PS2 Steam Chuffing in Neutral

PS2 Steam Light Flickering

Mux Fix

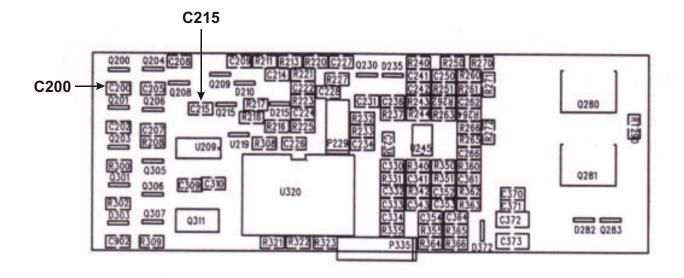
Step #1 Extract the pins from these two locations and swap them. These are the PCB grounds for both the MUX board and the engine board.

Ps2 Board Modification

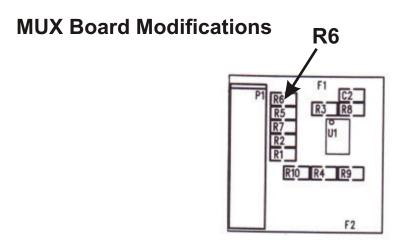
- 1. Swap the ground wires between the MUX transmit and DCS board in the tender. This is the previous mod that has been fully explained as a potential fix for other engines. (Royal blue wire swap.)
- 2. Remove C200 and C215 on the DCS processor board. Change R6 to 470 ohms 5% 603 package on the MUX transmit board.
- 3. On the boiler side, add an 18 gauge wire from pin #3 of the 10 pin connector to the ground lead of C4 on the MUX receive board. Disconnect the serial/Mux signal wire from the 10 pin connector pin 1, pull it out of the harnesses, and twist it around the new 18 gauge ground wire, then re-connect to pin 1. You may find it easier to simply wrap the 18 ga wire around the MUX signal wire. Please see the attached pictures for clarification of this step.
- 4. In the engine, change R12 from 3.32K ohms to 4.7K ohm 5% 603 package on the Receive Mux board.

Engine MUX board (receive) -

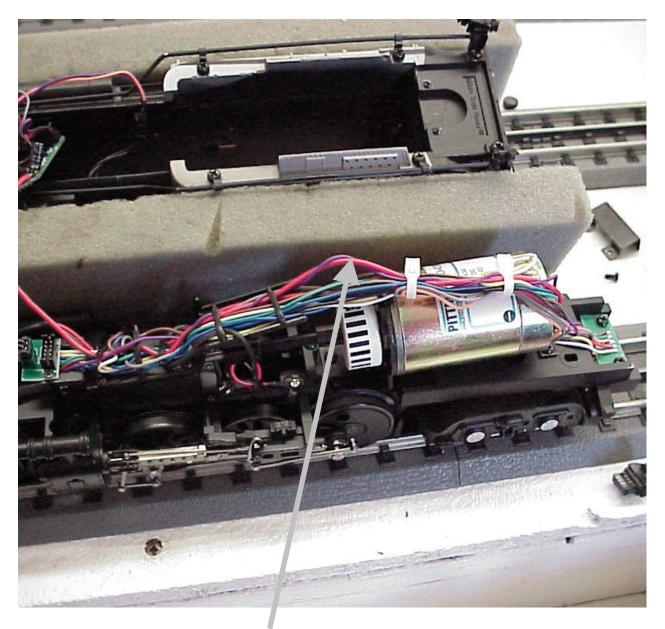
- Step #3 add 18 gauge wire to ground lead on C4
- Step #4 Replace R12 with 4.7K ohm 5% surface mount resistor.

MUX: Adding an 18 Gauge Wire

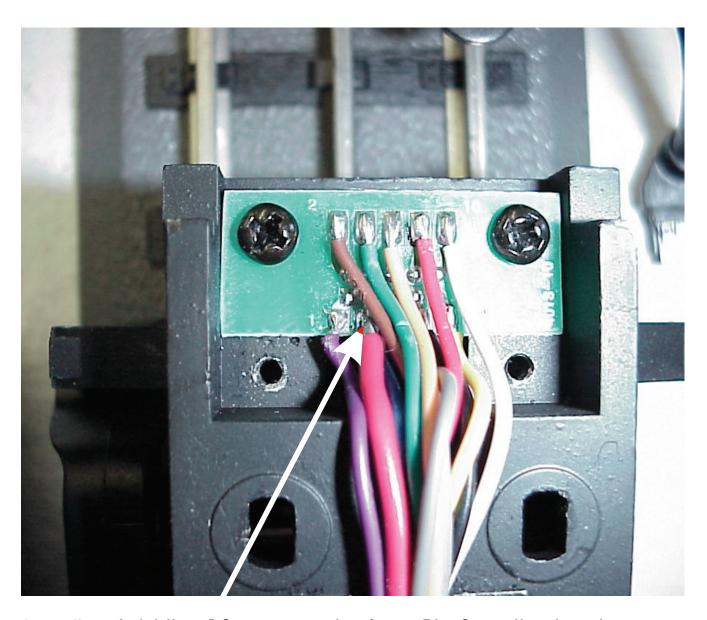
Step #3 Prior to solder the additional ground wire down, wrap it around the purple wire (MUX serial) that connects to Pin 1 on the tender interconnect board (see page 28 for a clearer shot of where this purple wire goes).

MUX: Adding an 18 Gauge Wire

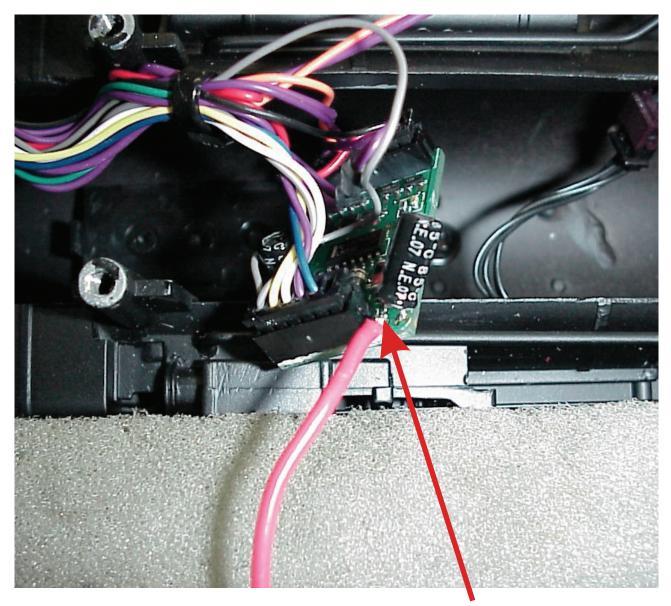
Step #3 Add the 18 gauge wire from Pin 3 on the tender interconnect harness. Do NOT remove the blue wire that is already on that pin.
